Document Review Report

Jordan River, Between 90th South and 78th South
Section 206 Restoration
Review of Planning Documents

West Jordan, Utah Section 206 Aquatic Ecosystem Restoration
Draft Detailed Project Report and Environmental Assessment
US Army Corps of Engineers Sacramento District
November 2003

Task Two Technical Memo
West Jordan, Utah Section 206 Environmental Restoration
Huffman and Carpenter
July 2000

Figure 1. Conceptual drawing of one possible fishing pond design.

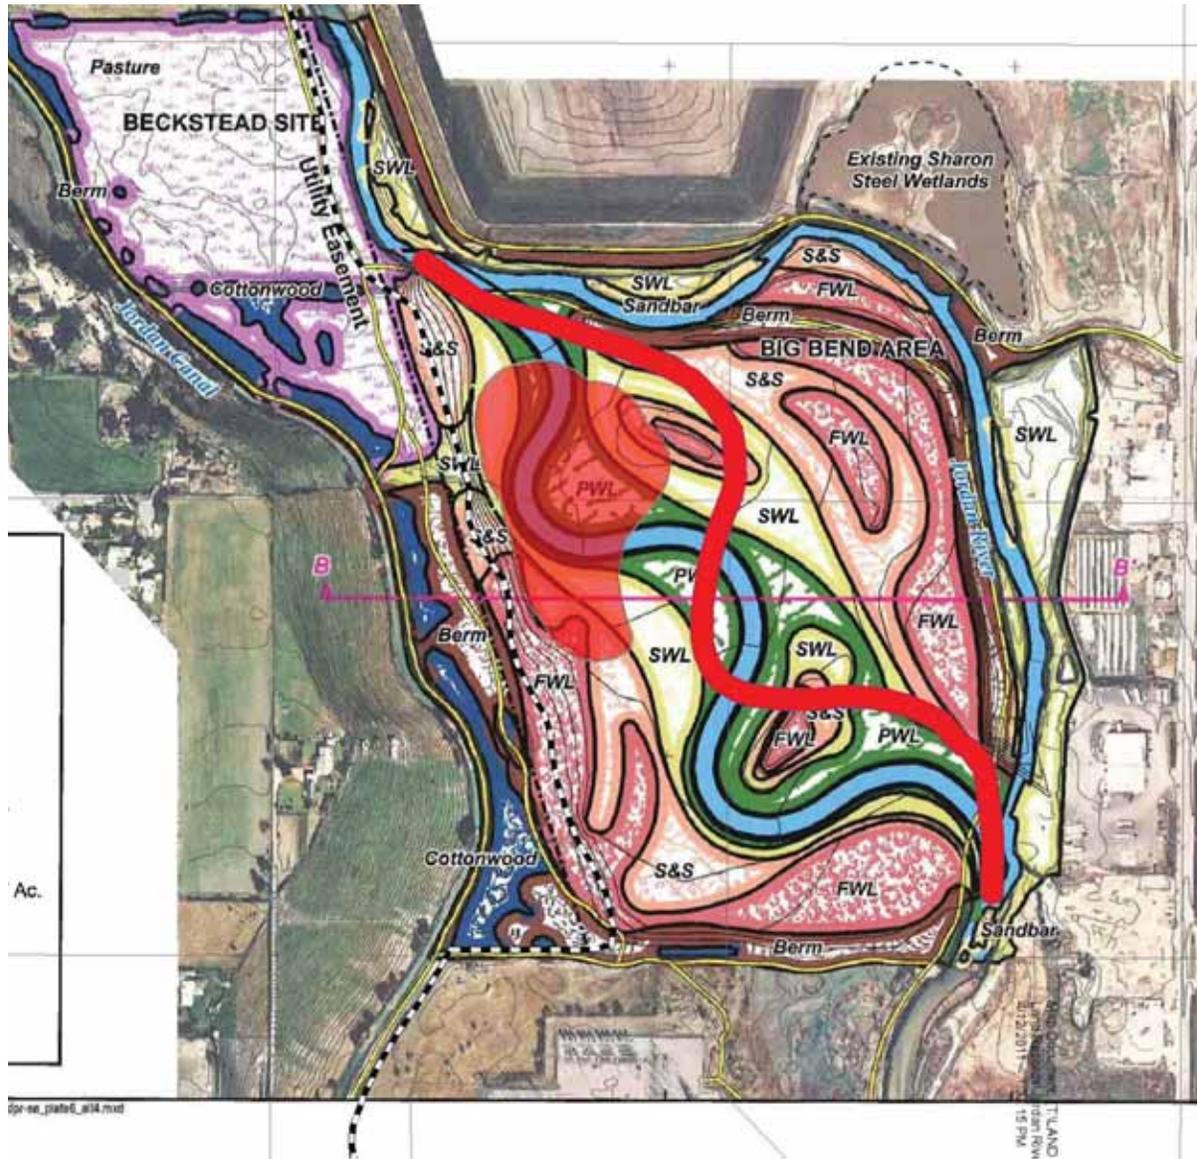
To further complicate the Alternatives Assessment, the city of West Jordan is now considering the addition of a large urban fishing pond within the project boundaries. Figure 1 shows a concept drawing of one possible pond location. Although early in the design phase, the City has suggested that they wish to include the pond within the project boundaries. If this pond is included in plans for the property, Alternatives 2 and 4 are no longer viable as proposed: leaving only the "No Action" alternative from the 2003 DDPR. Addition of the pond basically invalidates the alternatives assessment portion of the DDPR and essentially begins the entire process anew. These changes in land availability and project goals present the most pressing problem identified in the review process.

Figure 4. LIDAR data for the project area.

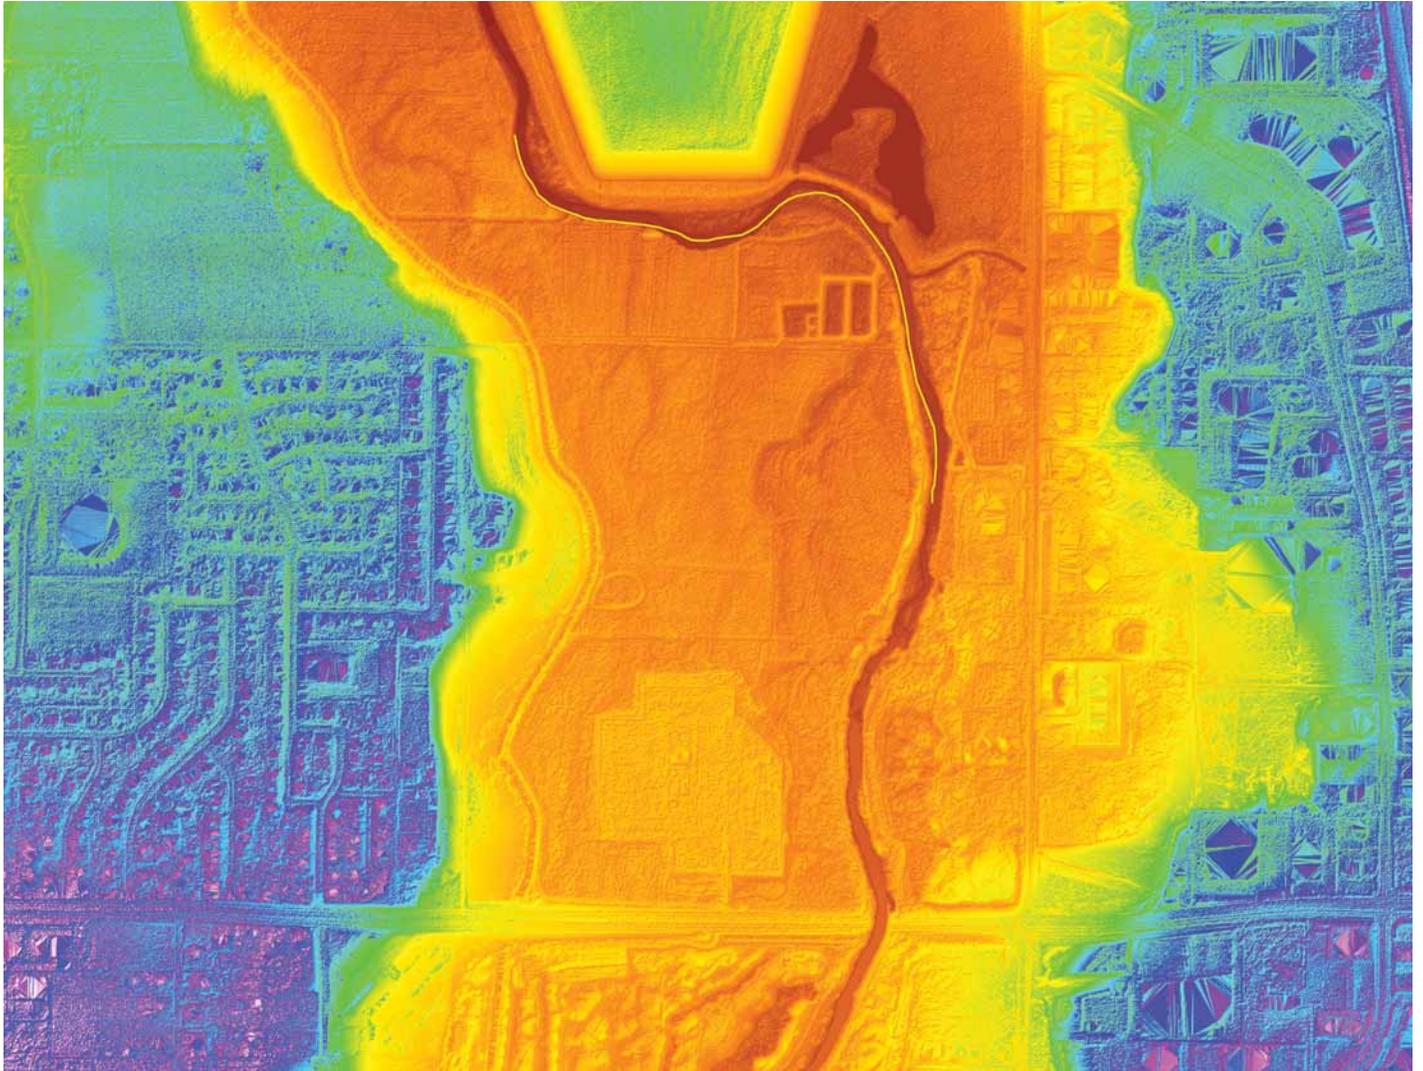
The Technical Memo and DDPR used topography based on ground surveys and aerial photogrammetry. These were the best data sources available at that time. More recently, LIDAR data have become available for the project site. These LIDAR data provide a high level of accuracy and resolution for design work and alternatives assessment. The LIDAR data are shown in Figure 4.

The vertical datum used for the LIDAR data is the North American Vertical Datum of 1988 (NAVD88). This datum is different than that used for the work in the Technical Memo and the DDPR, which was apparently based on the National Geodetic Vertical Datum of 1929 (NGVD29), although the datum is not referenced in the document. NAVD88 differs from NGVD29 by roughly 3 feet in the project area. When the DDPR data are adjusted by 3 feet, the elevations align reasonably well. It is important to note that the differences between these two datums vary from location to location, so a 3-foot adjustment is only useful for a rough estimate in the project area. Care should be taken to ensure that current planning efforts based on the LIDAR data account for these differences.

Figure 5. Proposed semi-permeable rip-rap levee.

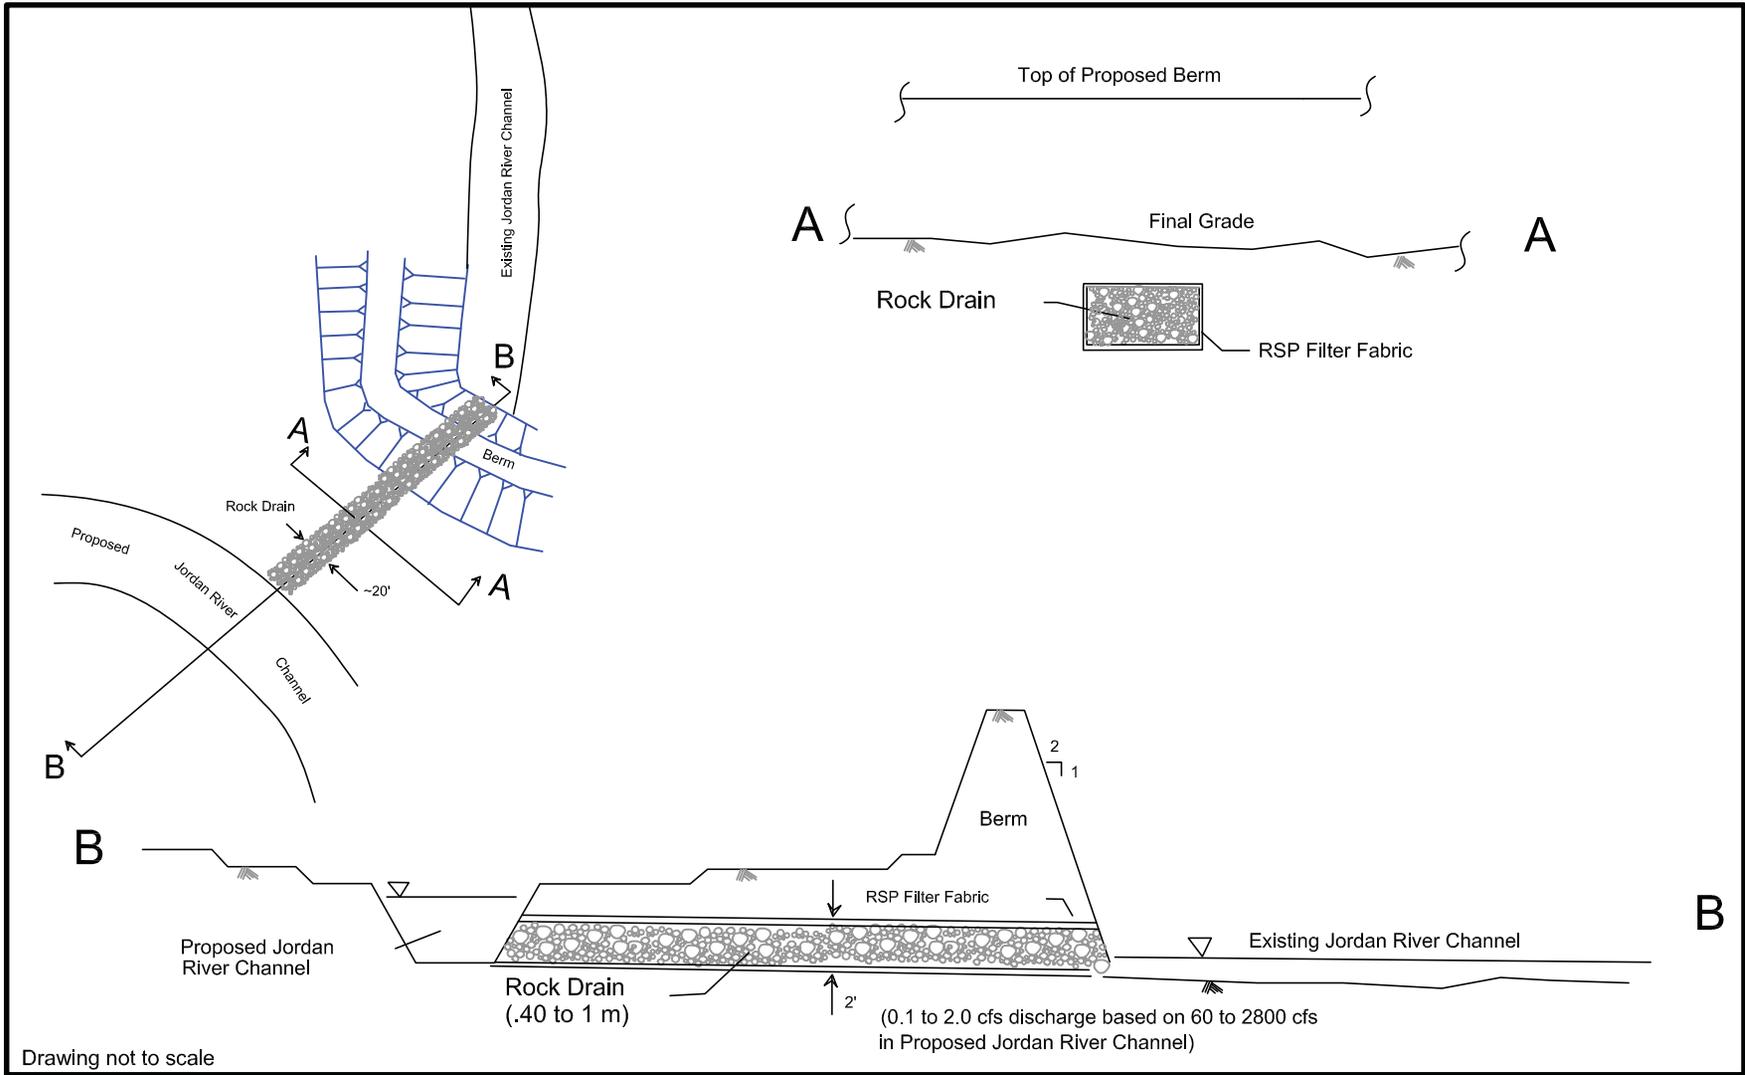
The DDPR includes plans for a proposed semi-permeable riprap levee (Figure 5) that would allow water to drain from the new meander channel back into the old channel to maintain the riparian vegetation and to supply water for the Sharon Steel Wetland. This drain is likely not needed because the groundwater in the area will remain quite high and should keep the old channel filled with water at all

times. Recent groundwater studies of the Jordan River suggest that this reach is a gaining reach, meaning that groundwater levels slope toward the river channel. The proposed design appears to be adequate but has a 2-to-1 slope on the downstream side. Steep slopes like this one are far less stable than more gradual slopes which occur over longer distances. I recommend that the slope be reduced to 6-to-1 or more on the back side of the levee, if it is deemed to be needed. In addition, high flows should be allowed to overtop this levee, whenever they occur. During periods of extremely high flow, the entire floodplain will be inundated. It would be better to allow the water to overtop the levee and flow down the old channel rather than trying to prevent it from overtopping. Given the extremely low slope in the area, water will likely be ponded against the back side of the levee before it overtops. The high water on the back side of the levee helps limit any tendency to headcut as water flows over the top, especially if the slope on the back side is shallow.

Figure 7. Plot of cross section from Figure 6, showing the existing ground surface from adjusted LIDAR data (blue line) and the proposed ground surface (red line). Note that much of the proposed surface requires between 4-5 feet of excavation and lowering of the existing ground surface.

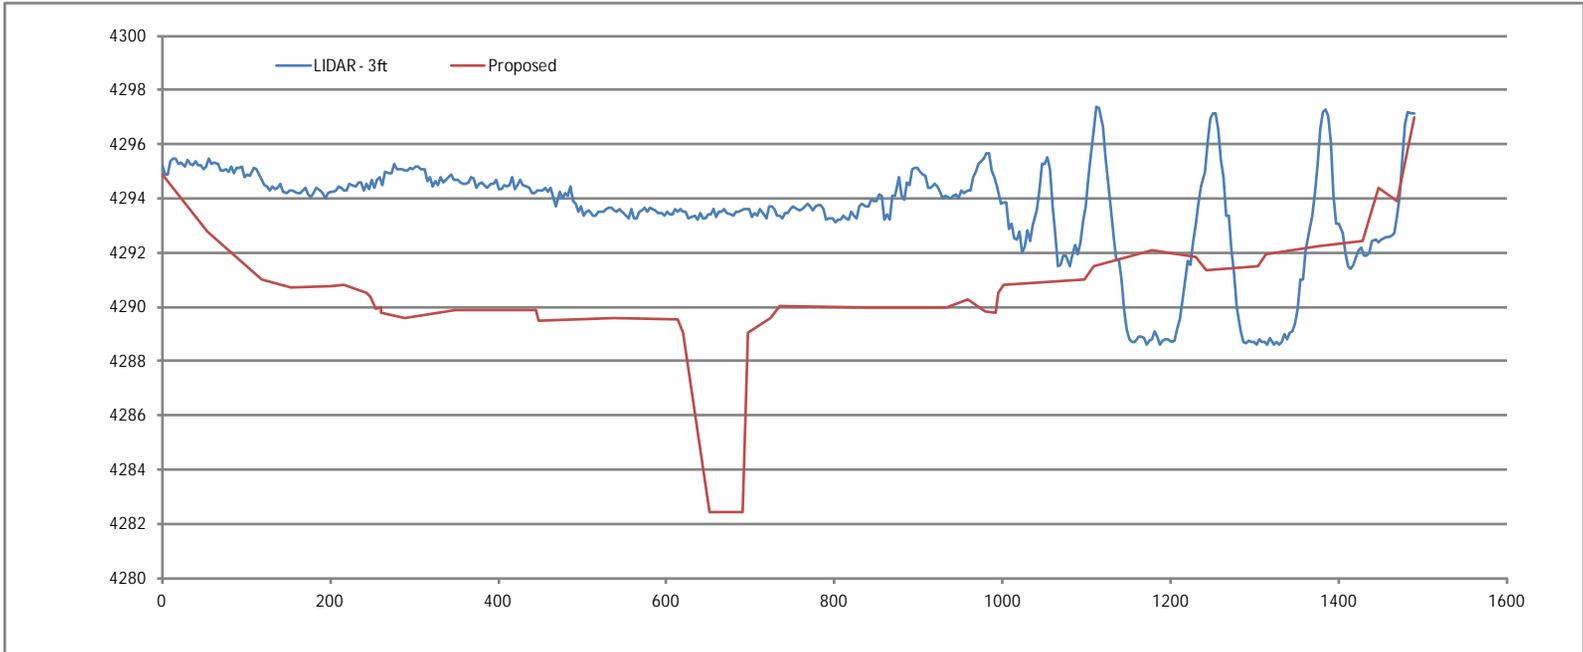
The "Sitework" category represents the single largest cost associated with the proposed restoration alternatives. The costs for this category are high because of the quantity of excavated material. Examination of the HEC-RAS models used to evaluate the alternatives shows that enormous volumes of

floodplain material will need to be removed to lower the floodplain to an elevation where overbank flooding can occur: a primary goal of the project (Figures 6 and 7). Much of the floodplain will need to be lowered by 4 to 5 feet in order to be accessible to the river during frequent flood events.

The 2003 DDPR calls for 240,000 cubic yards of excavated material, for both Alternatives 2 and 4, at a unit cost of \$5 per cubic yard, plus a 20% contingency. A unit cost of \$5 per cubic yard is applicable today, thus the "Sitework" portion of the cost estimate is still reasonable in 2013 dollars, but **only** if the spoil material does not need to be trucked off-site at the project's expense (discussed at length in subsequent paragraphs). The wording in the DDPR is far too broad, explaining: *"Top soils would be excavated and stored on-site. Additionally, soils capable of supporting wetland vegetation would be stockpiled and reused. The remaining excess spoil material will be sold to offset excavation and transportation costs. If a buyer cannot be located, the excess spoil will be dumped at a site designated by the City of West Jordan within 20 miles of the construction site."*
